**UNITED STATES  
NUCLEAR REGULATORY COMMISSION  
ADVISORY COMMITTEE ON REACTOR SAFEGUARDS  
WASHINGTON, DC 20555 - 0001**

April 26, 2012

**SUBJECT: DRAFT COMMISSION PAPER, "RISK-INFORMED REGULATORY  
FRAMEWORK FOR NEW REACTORS"**

Figure 1. Relative Risk Significance Concept

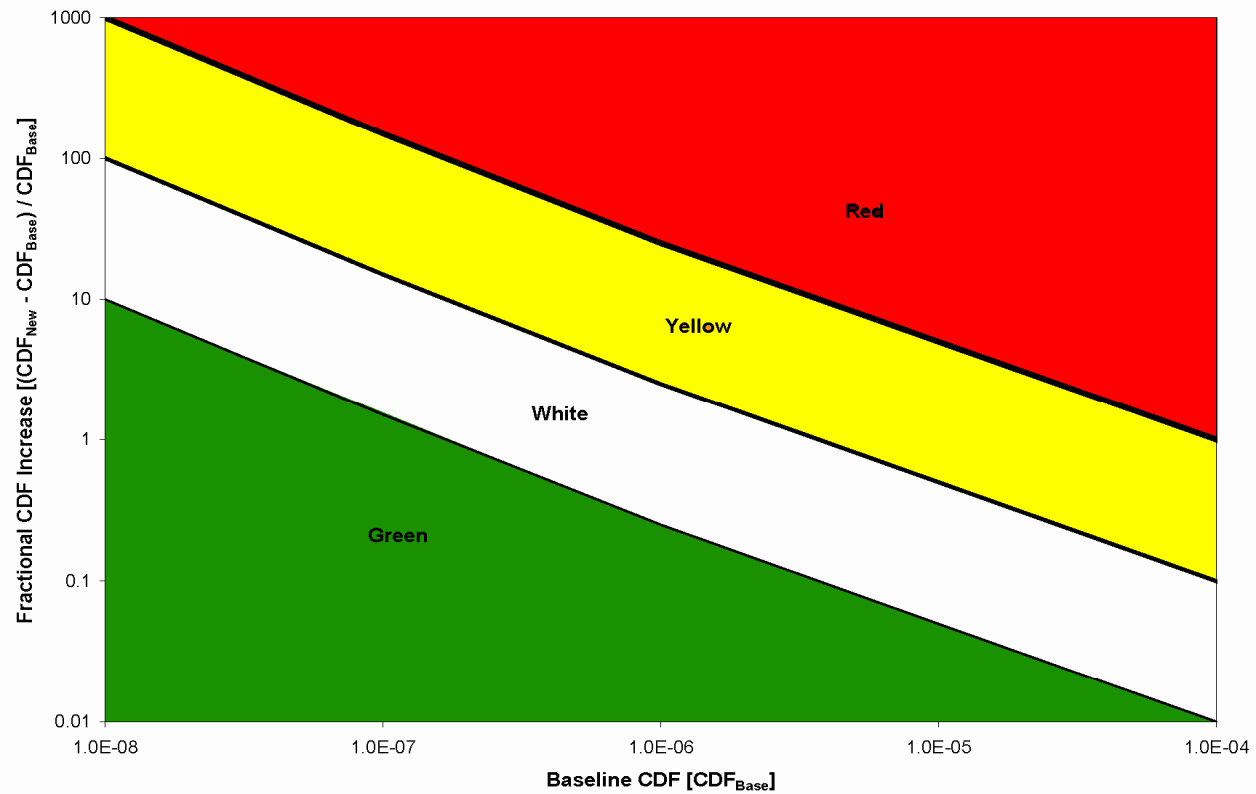
A rigid application of relative risk measures would not address the Commission direction to provide greater operational flexibility for reactors with increased margins of safety. Figure 1 is a conceptual framework in which the permitted relative change in CDF is dependent on the baseline CDF. The logarithmic scales for this metric accomplish the stated desire to provide increased operational flexibility as the absolute safety margin increases. The numerical values for the vertical scale can be selected to preserve the SDP metrics that are currently applied for operating reactors and to provide appropriate numerical discrimination for reactor oversight and other regulatory decisions for new reactors.

Example values are shown on Figure 1 to illustrate how this concept could be implemented in practice. If the baseline CDF were  $1.0 \times 10^{-4}$  event per year, a White significance finding would be triggered if the CDF increases by 1%. This is equivalent to the current SDP threshold absolute increase of  $1.0 \times 10^{-6}$  event per year. If the baseline CDF were  $1.0 \times 10^{-8}$  event per year, a White significance finding would be triggered if the CDF increases by a factor of approximately 10. This is equivalent to an absolute increase of  $1.0 \times 10^{-7}$  event per year. As intended, the corresponding significance determination appropriately maintains the enhanced level of overall plant safety, supports improved decisions for increased regulatory oversight, and provides substantially increased operational flexibility, compared to current reactors.

This concept should be implemented by consistently extending the decision framework of Regulatory Guide 1.174. Appropriate values for these metrics, the shapes, and the slopes of the significance determination transitions would be developed through stakeholder interactions, informed by the available tabletop exercises or an expanded set of case studies.
